Document ID: IK0800442
Revision: 0
Created: 7/11/2013
Last Modified: 8/22/2013
Author: Gregory Mackey

Title: Auxiliary Battery Box - Cover Difficult to Remove**Applies To: Prostar or any vehicle with Feature Code 0008XGG (auxiliary battery box)****DESCRIPTION**

Figure 1 - Replace bolts causing the interference

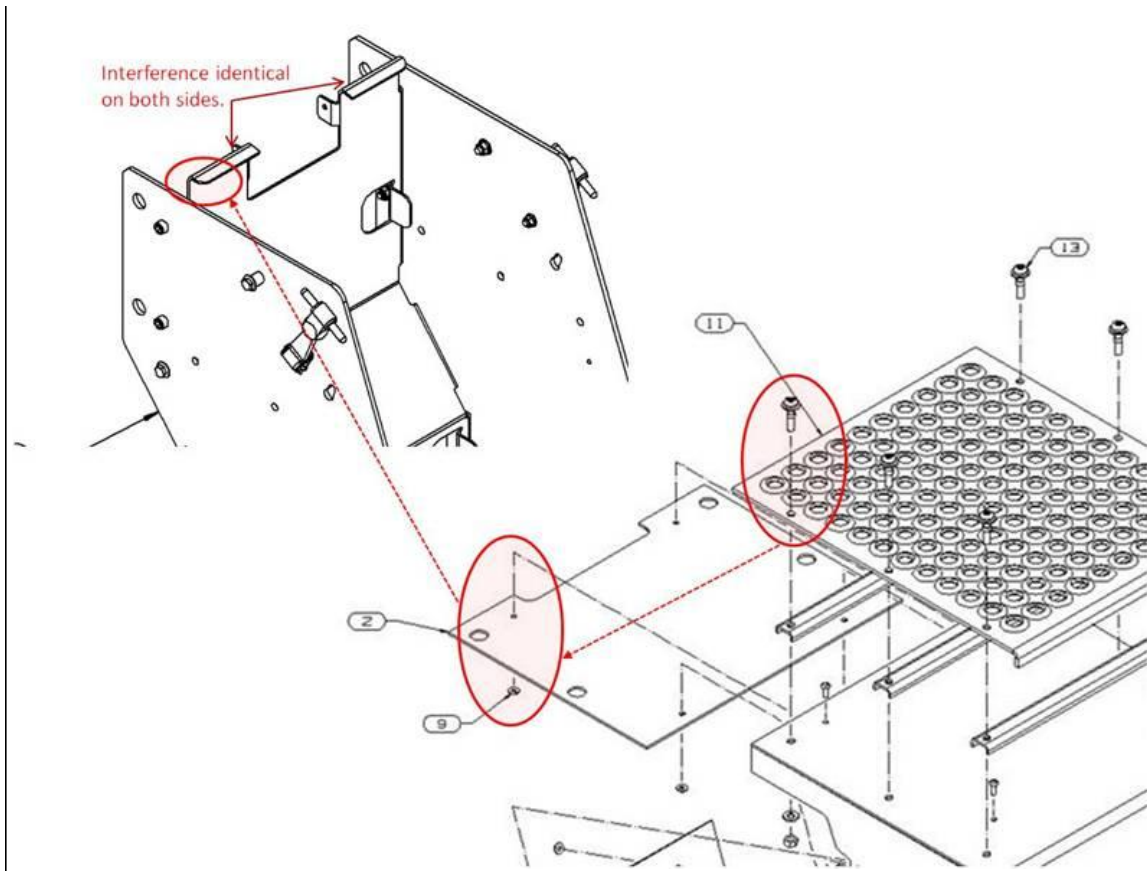
An interference condition can occur between cover bolts or step plate and a flange on the back plate of the battery box. This document describes the condition and remedy of replacing the existing bolt with a shorter bolt to eliminate the interference condition.

Replace 2 - 3804756c1 M8x35mm bolts indicated as item 13 in Figure 1 w/ 2 - 3588153c1 M8x30 bolts.
